# **Attachment A5**

**Proponent's Draft DCP Amendment**

## Site Specific Development Controls – Green Square Sites 8A and 8B Draft amendments to Green Square Town Centre Development Control Plan 2012

**Figure 3.28 Through-Site Link Sites 8A and 8B – Section**  
(New graphic below proposed to be inserted)

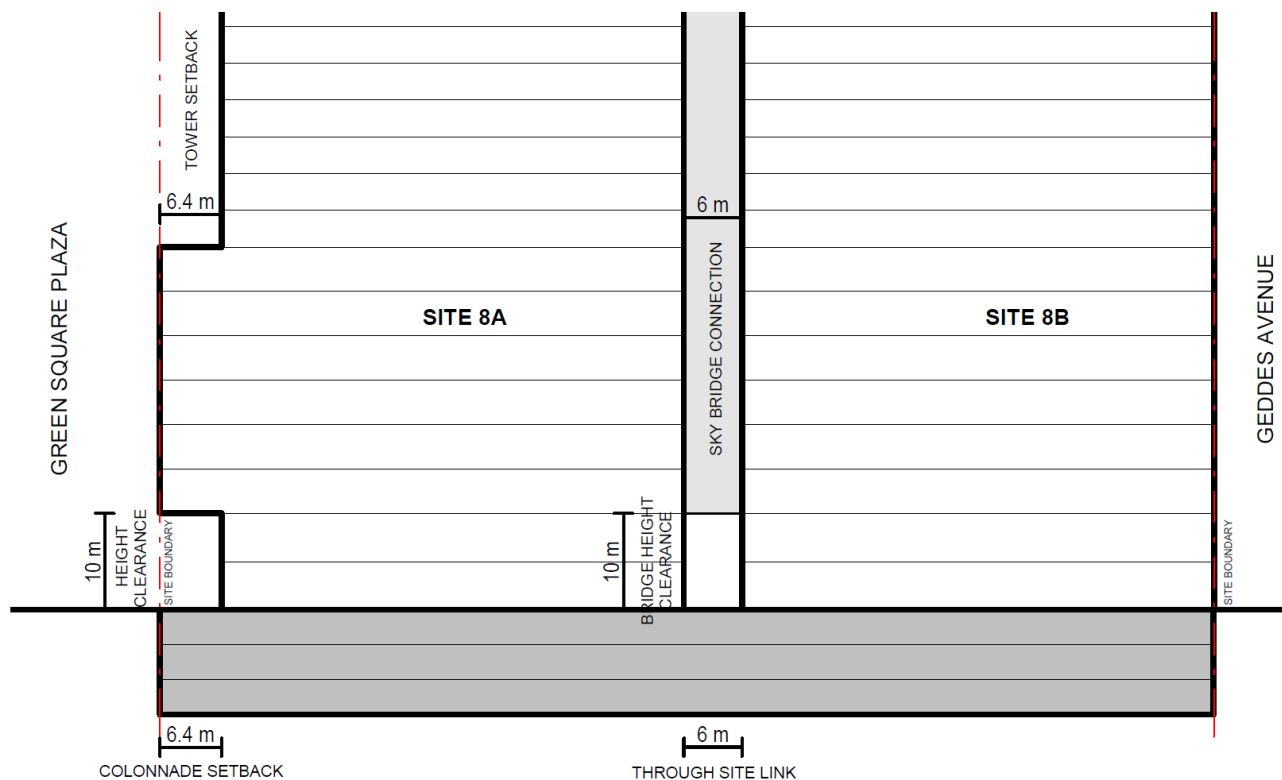
- 10) Between sites 8A and 8B, ~~3m~~ **20m** wide ~~fully-clear~~ glazed sky bridges may connect the development sites at levels greater than 10m above ground level, **in accordance with Figure 3.27: Through-site links and arcades, Figure 3.28: Through-Site Link Sites 8A and 8B – Section and Figure 3.29: Through-Site Link Sites 8A and 8B – Plan**
